STAFF SUBMITTAL

Approval of After-the-Fact Variances with Special Conditions to
Moloa'a Irrigation Cooperative, Gerard Bosman, and
Oasis Water Systems, Inc.
MIC 1(Well No. 2-1019-012)
TMK (4) 4-9-012:022, Anahola, Kaua'i

SUMMARY OF REQUEST:

The applicant requests approval of after-the-fact variances for the well depth exceeding the ¼ depth limitation and not meeting the minimum well casing thickness from provisions of the 2004 Hawai'i Well Construction and Pump Installation Standards.

Figure 1. Comparison of the Water Level in the MIC-1 Well During its 48-Hour Constant Rate Pump Test with the Nawiliwili Harbor Tide Level

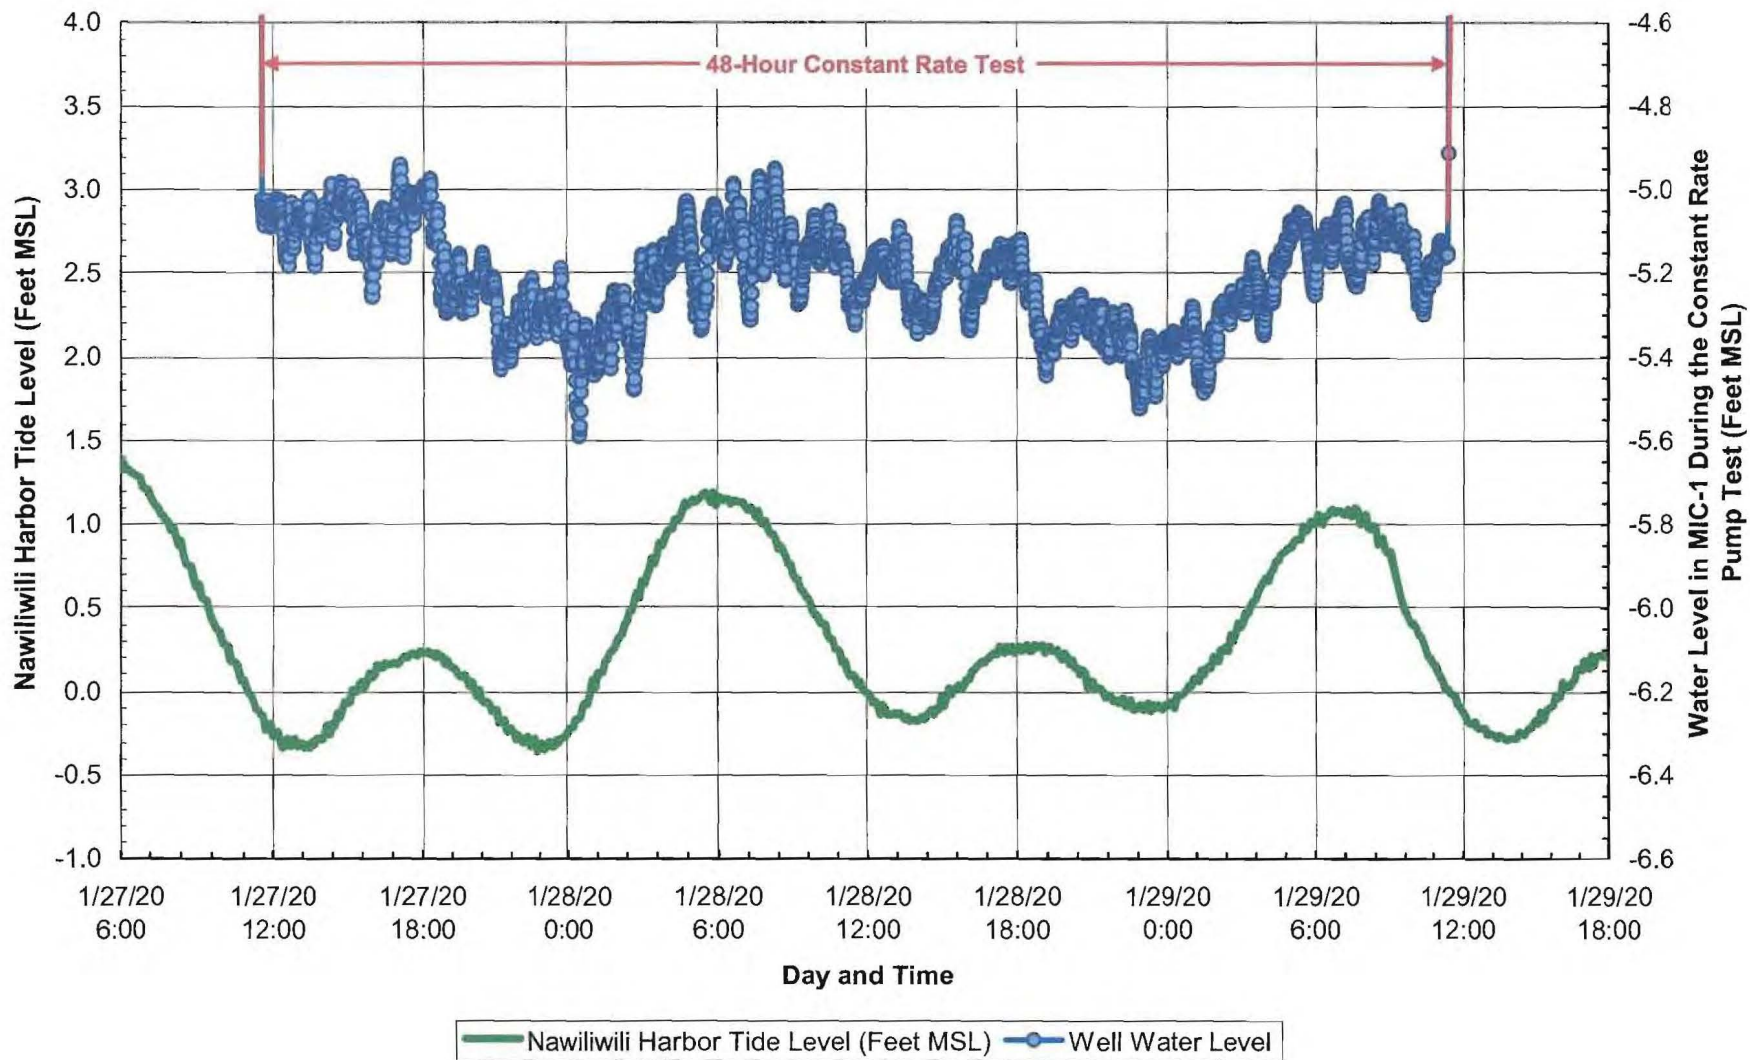
- The only actual aquifer encountered, the one the well draws from, starts at a depth of 270 feet. It is a basal aquifer (based on its response to the ocean tide shown on Figure 1) and it is also confined. There is no cross-connection of aquifers.
